REMARKS

Amendments to the Drawings

FIG. 1

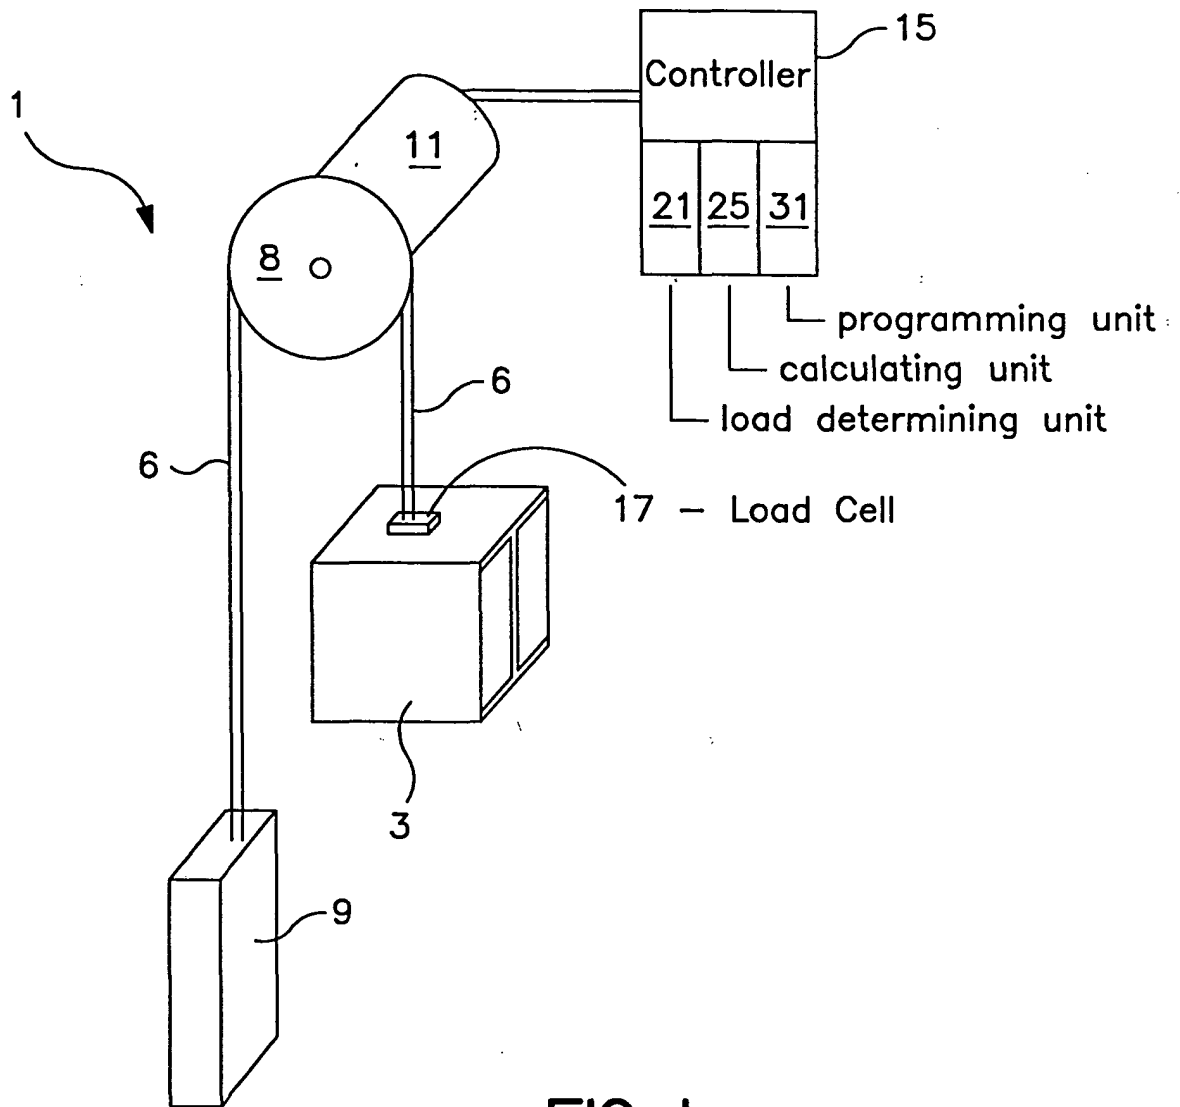
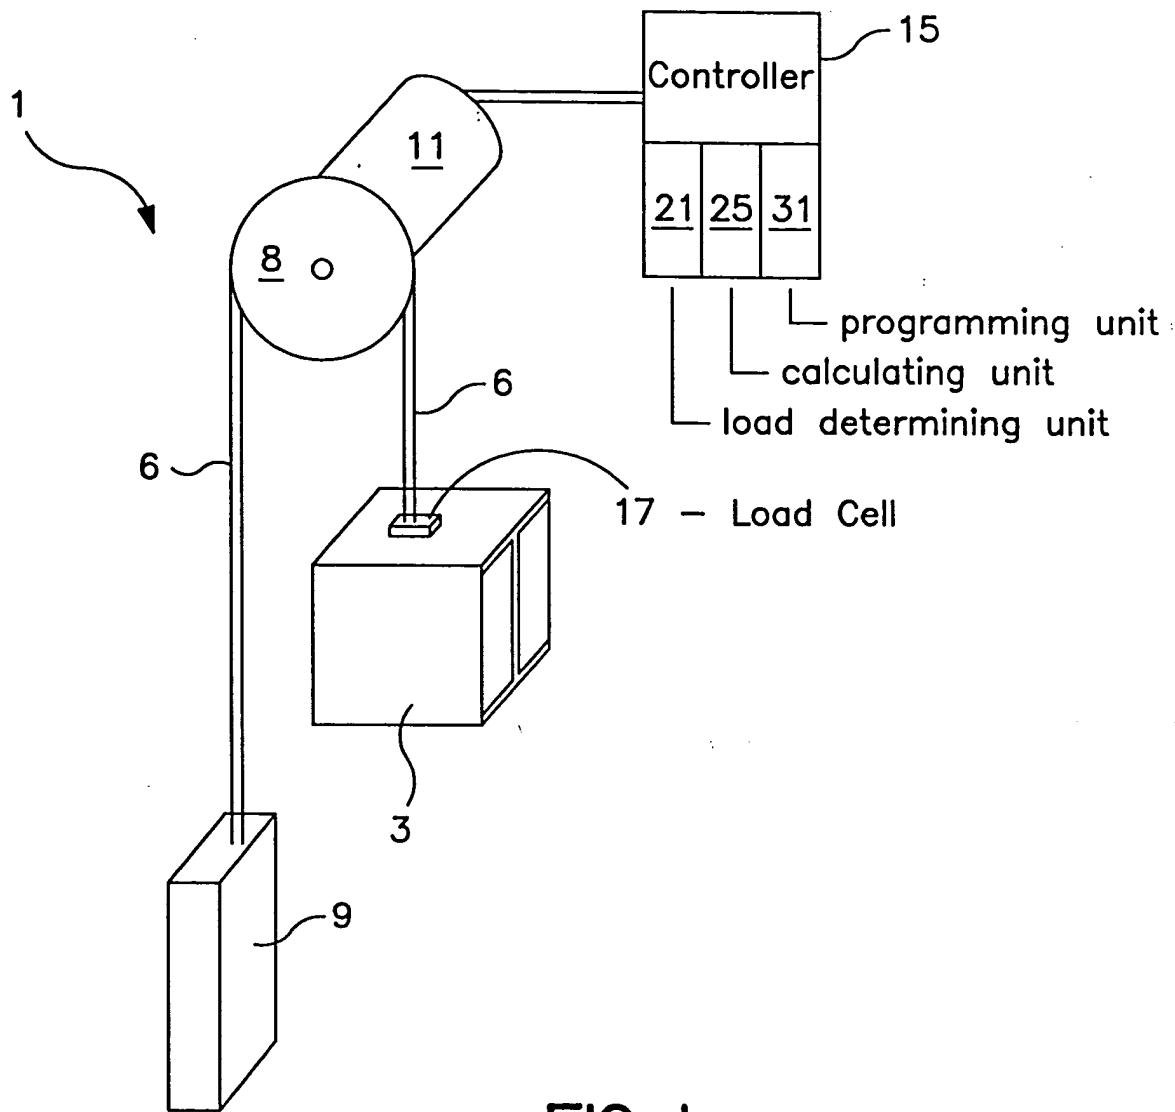
The attached drawing sheet, comprising Figure 1, replaces the drawing sheet as originally filed in the parent application, serial no. 10/113,517. The amendments to Figure 1 parallel the amendments made to Figure 1 in the parent application, which were approved by the Examiner. Specifically, figure elements 17, 21, 25, and 31 of Figure 1 have been labeled with a text description. Support for the amendments to Figure 1 is provided by the specification as shown in the table below, wherein paragraph numbers refer to those of the application.

Figure element(s)	Description	Support in specification
17	Load Cell	Paragraph [0024]
21	Load determining unit	Paragraph [0025]
25	Calculating unit	Paragraphs [0025] and [0026]
31	Programming unit	Paragraph [0026]

An annotated sheet, in which the change has been highlighted in yellow, is attached for the Examiner's reference.
